Questions from Pre-Proposal Meeting for RTIS Project – V.3

WIRING DIAGRAMS FOR LED DISPLAY SIGN AND PUSH BUTTON

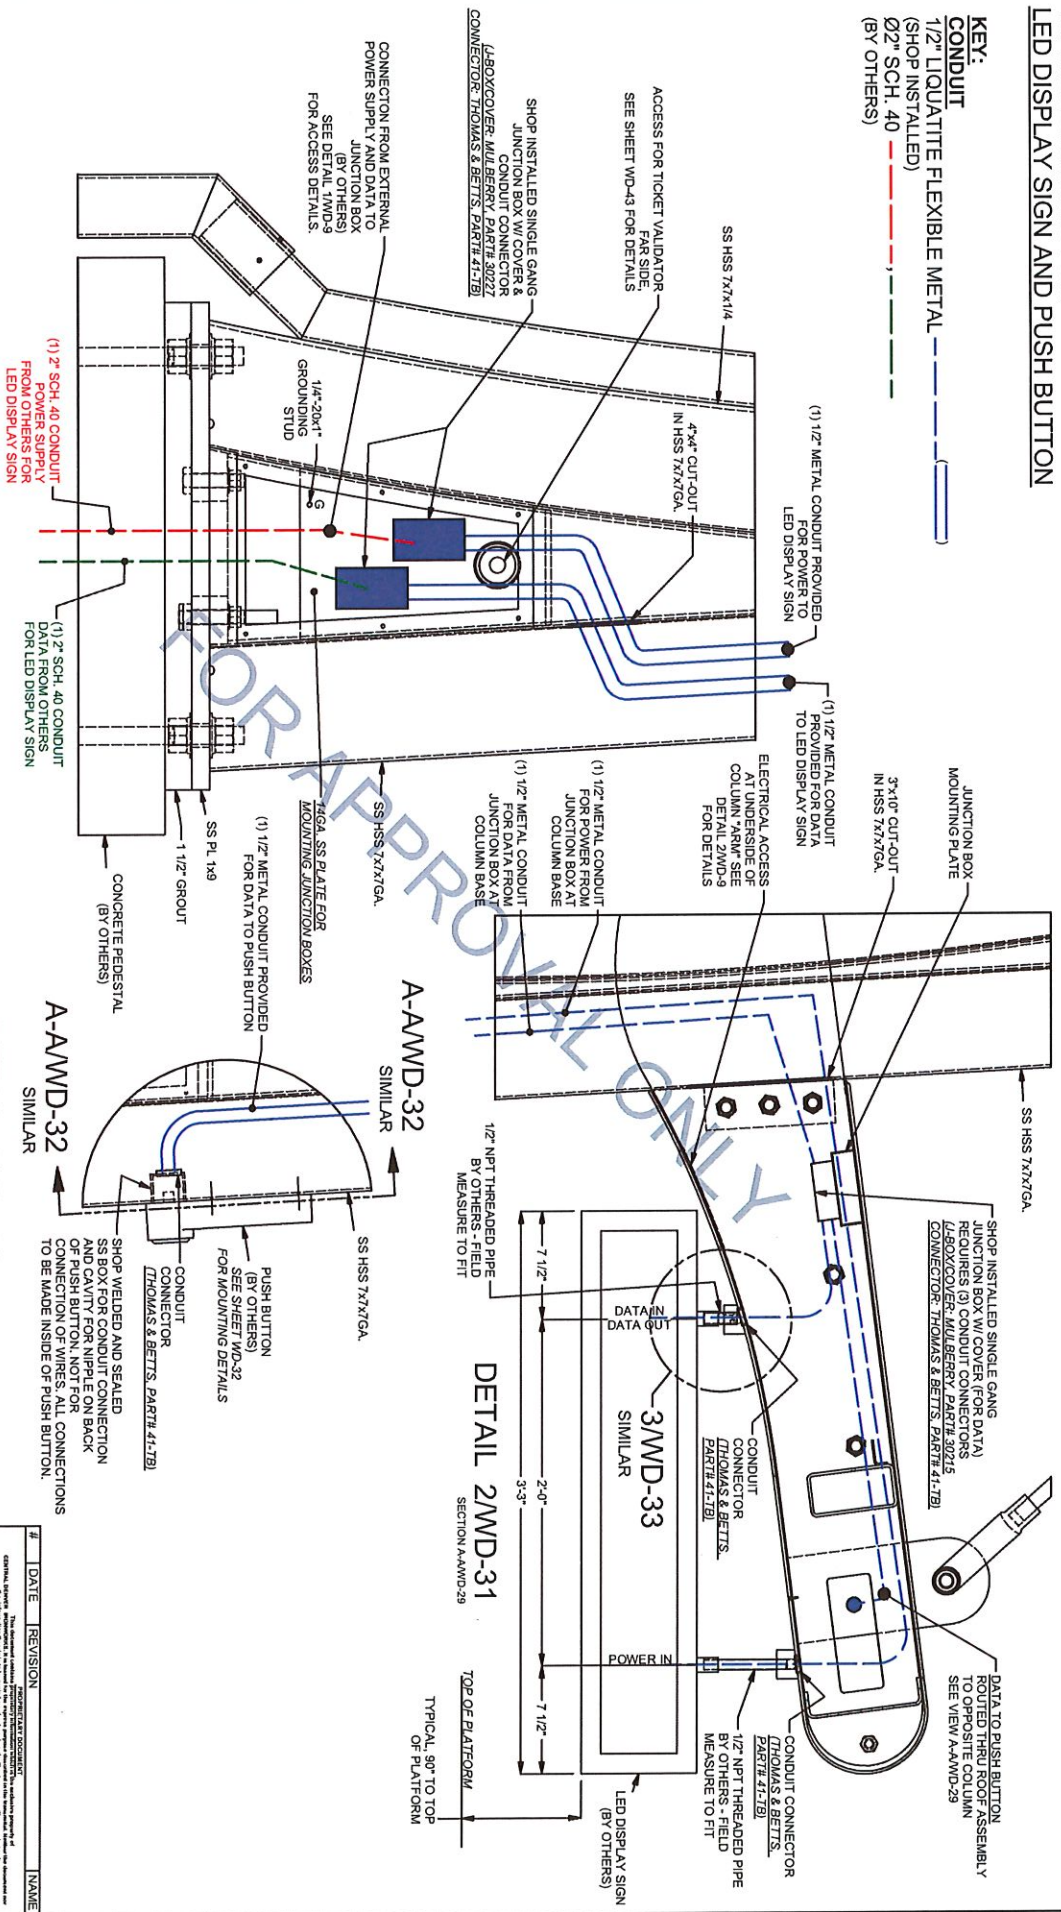
1. Can you please confirm that the power and RJ45 Data connections will be pre-wired to the sign mounting point, and that any wiring requirements for power and data connection on the proposers is limited to getting the power and data from the interior of the sign to the sign mounting connection point. Further, can ITP provide updated drawings to illustrate this?

3. For Power and Ethernet Cabling, Where will the Agency hand off the cabling to us for the signage? Will it be at a junction box near the signage install location?

Answer. *Yes, power and RJ45 data connections are prewired from the communications cabinet on the platform through the structure to the pre-drilled holes for mounting the sign. The only wiring that will need to be run is from the sign to the ADA push to talk button for audible announcements of arrival times. See attached drawing with network and power wiring in the shelter structures.*

Answer. *Power and RJ45 data connections are prewired from the communications cabinet on the platform through the structure to the pre-drilled holes for mounting the sign. The only wiring that will need to be run is from the sign to the ADA push to talk button for audible announcements of arrival times. See attached drawing with network and power wiring in the shelter structures.*
